Site Plan
1632 River Road
Puyallup, WA 98371

PROJECT NAME:
LEGEND AUTO ADDITION

PROJECT ADDRESS:
1632 RIVER ROAD
PUYALLUP WA 98371

Floor Plans
1632 River Road
Puyallup, WA 98371

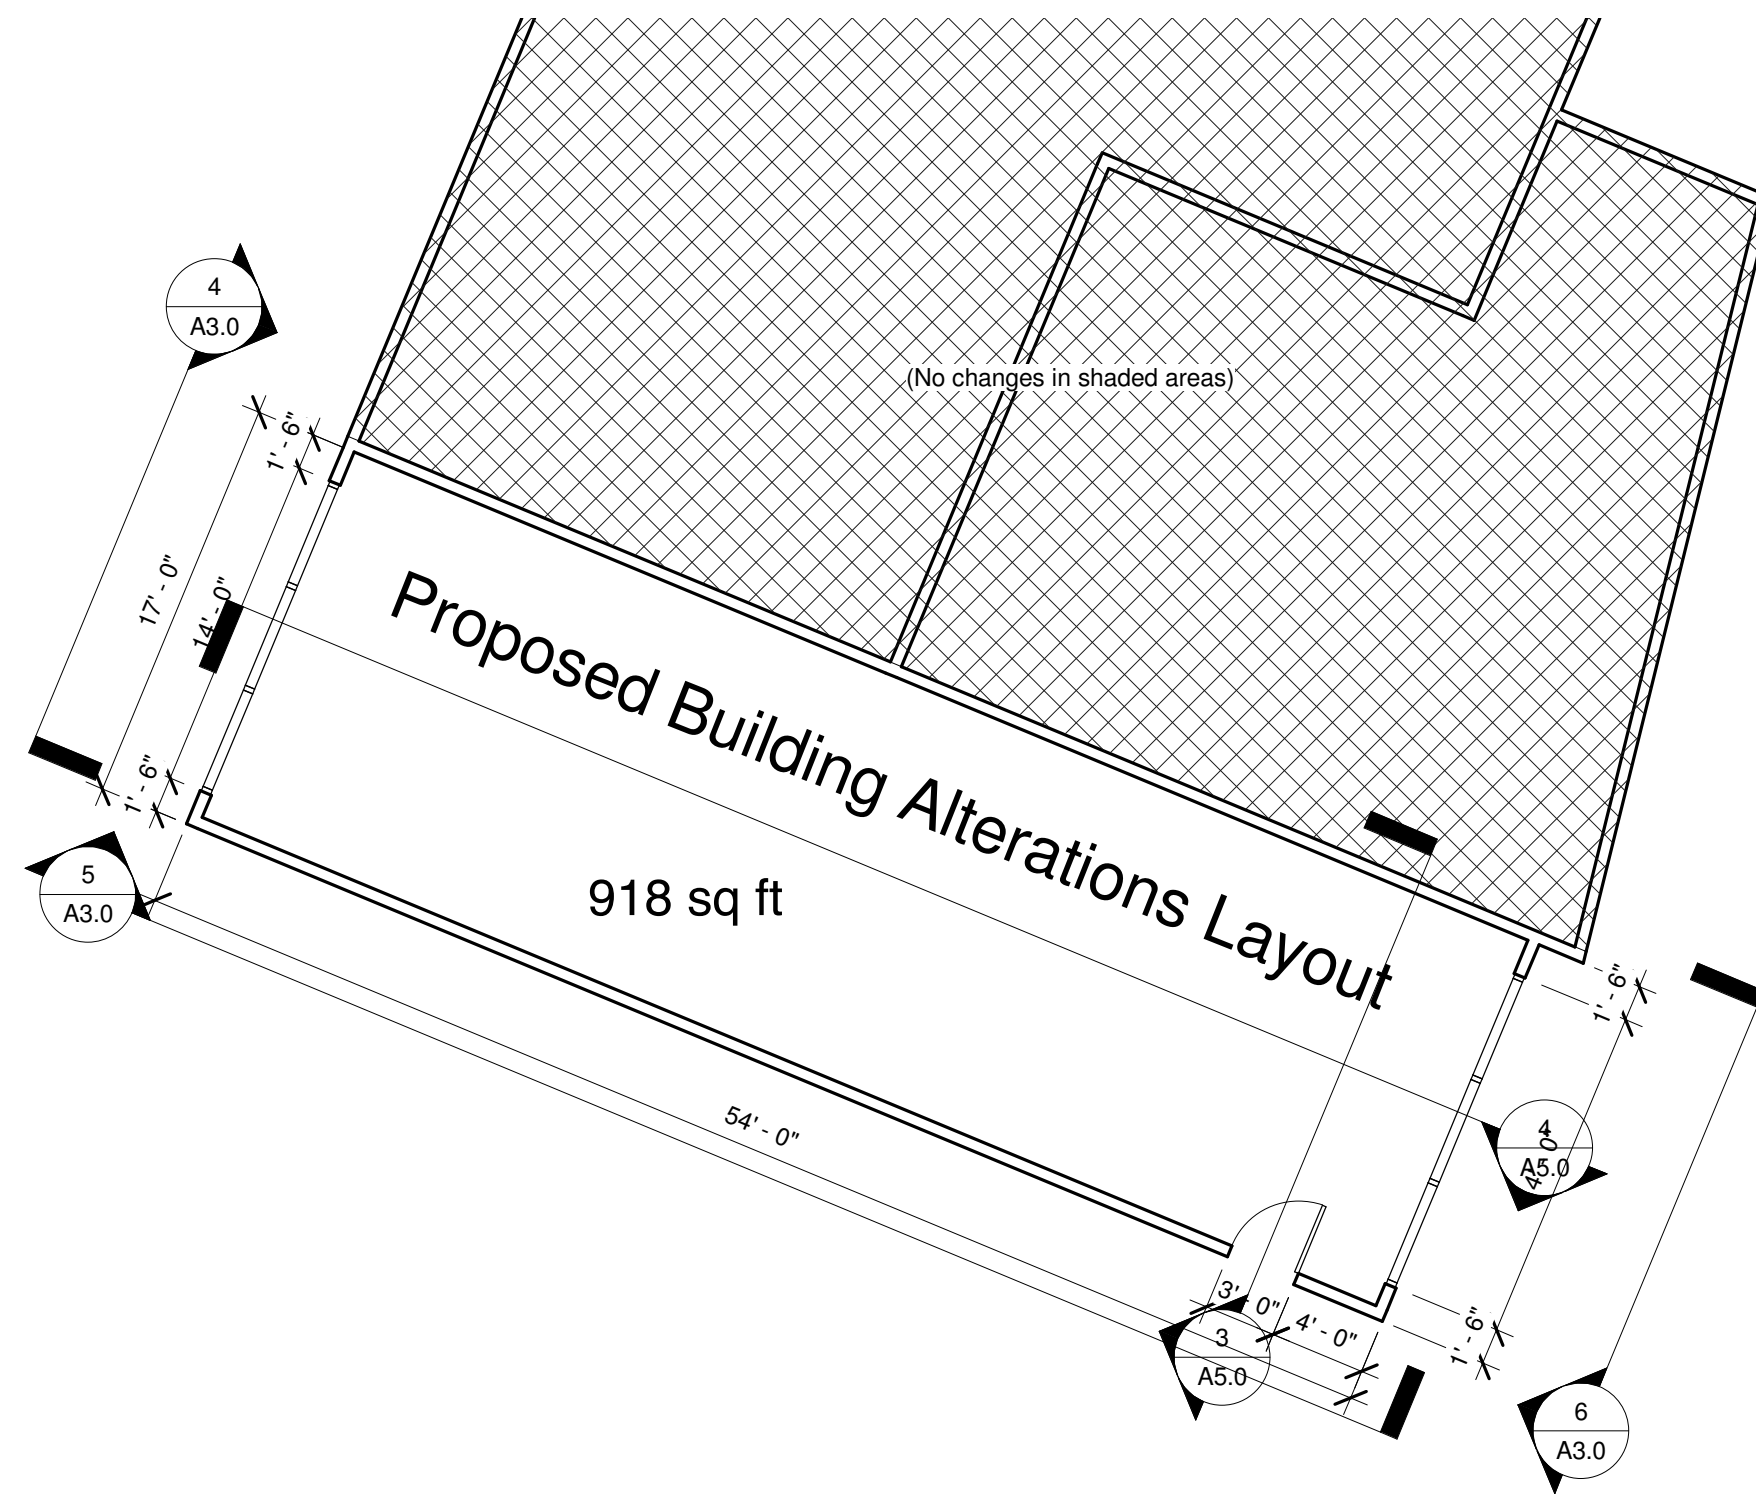
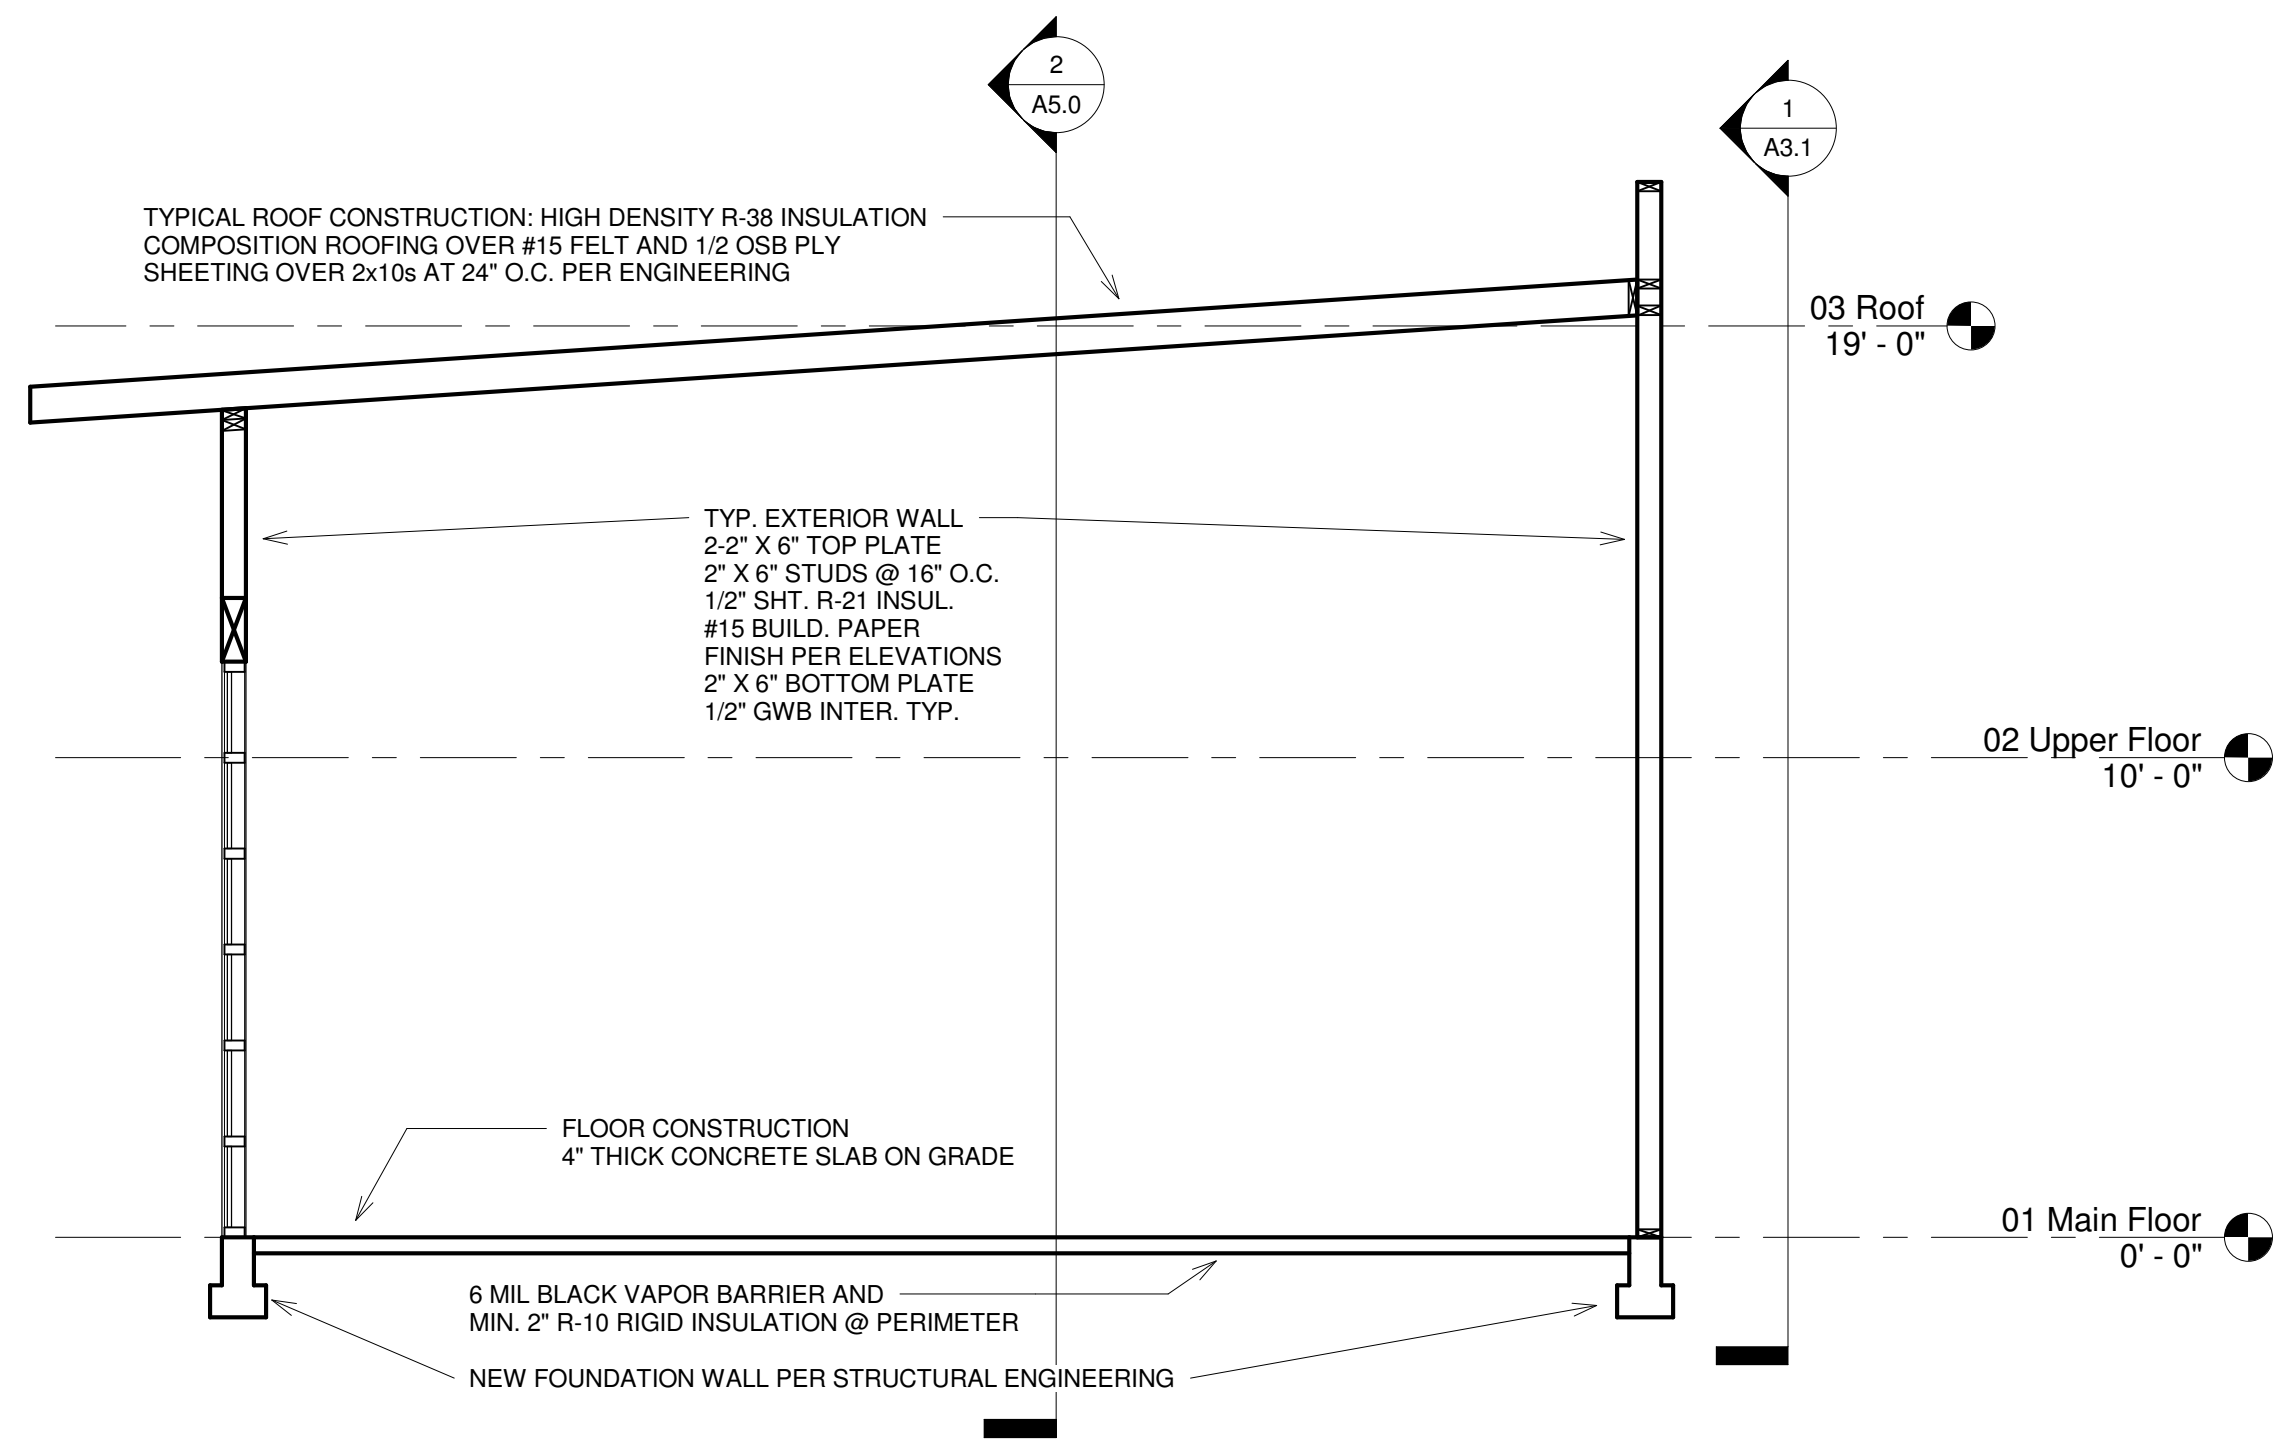
The Energy Worksheets reference sheet A4.0 for all applicable Energy Code calculations, equipment information, etc.; however, no Energy Code information is provided on sheet A4.0 or anywhere else in the plan set. Please provide all necessary Mechanical, Lighting, and Electrical drawings [1570 PLANS, sheet A4.0].

Please note the uses for the new space and existing spaces (shop, office, retail, etc.). Note any separation requirements between the revised space and existing spaces per the 2018 International Building Code [1570 PLANS, sheet A4.0].
